MWO 9-2350-267-20-4

MODIFICATION WORK ORDER

MODIFICATION OF M992 FIELD ARTILLERY AMMUNITION SUPPORT VEHICLE (FAASV) AUTOMATIC FIRE EXTINGUISHER SYSTEM (AFES) DECAL KIT

30 June 1992

Figure 1

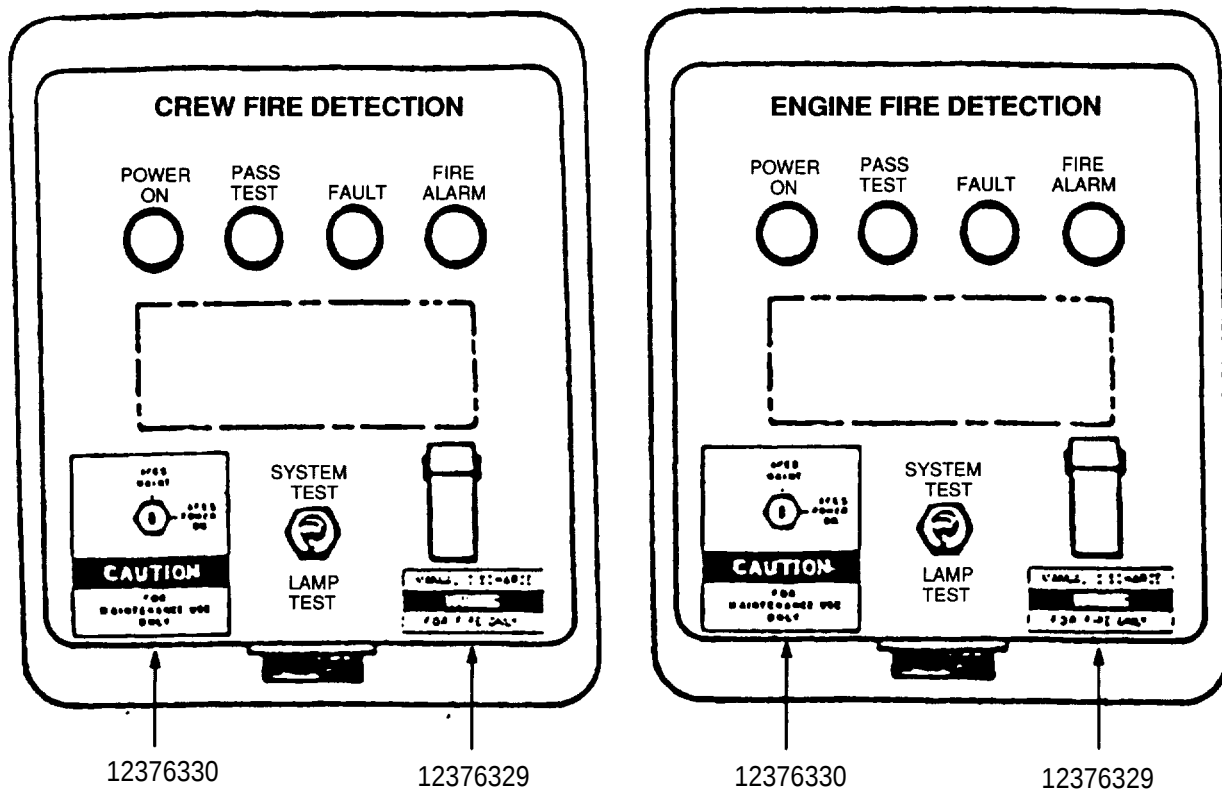
Installation of Warning Labels 12376329 and 12376330 to Test and Alarm Panels.

1. Place "MAINT" switch on Engine Test and Alarm Panel and Crew Test and Alarm Panel in the vertical position (AFES MAINT).
2. Clean the surface areas on the Engine and Crew Test and Alarm Panels with detergent.
3. Remove the protective backing from labels 12376329* and 12376330*, and position them on the Engine and Crew Test and Alarm Panels as shown in Figure 1.

Figure 2

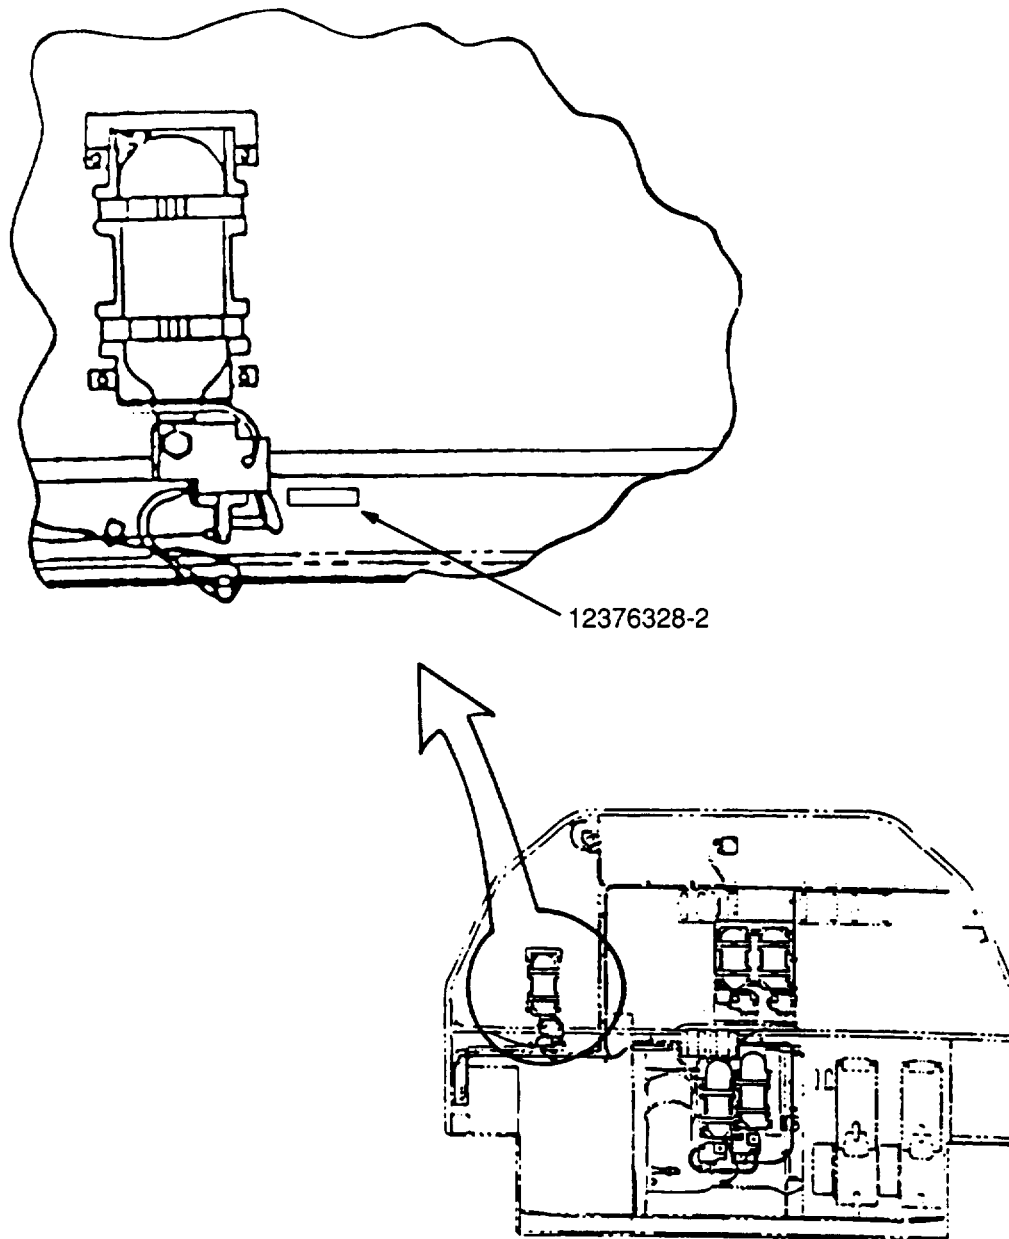
Installation of Warning Labels 12376328-2 to APU Bulkhead.

6. Clean the surface area on the APU Bulkhead where the label is to be placed (reference Figure 2) with detergent.

7. Remove the protective backing from label 12376328-2* and position on the APU Bulkhead as shown in Figure 2.

Figure 3

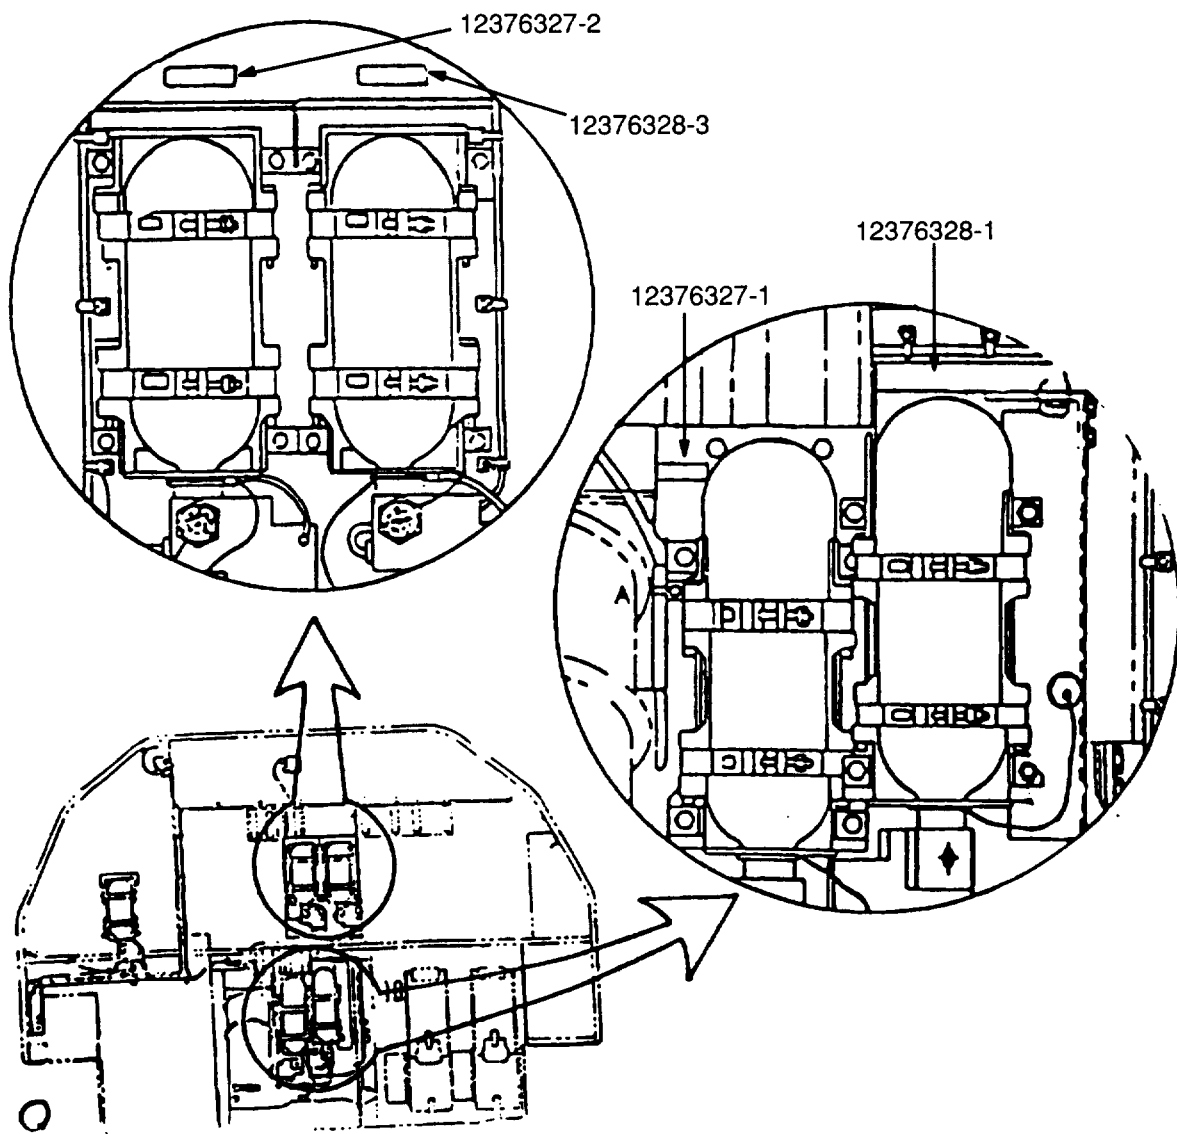
Installation of Warning Labels 12376327-1, 12376328-1, and 12376328-3 behind Projectile Rack

NOTE: Steps 11 and 12 apply to labels 12376327-1*, 12376327-2*, 12376328-1*, and 12376328-3*.

11. Remove the protective backing from appropriate label and position as shown in Figure 3.
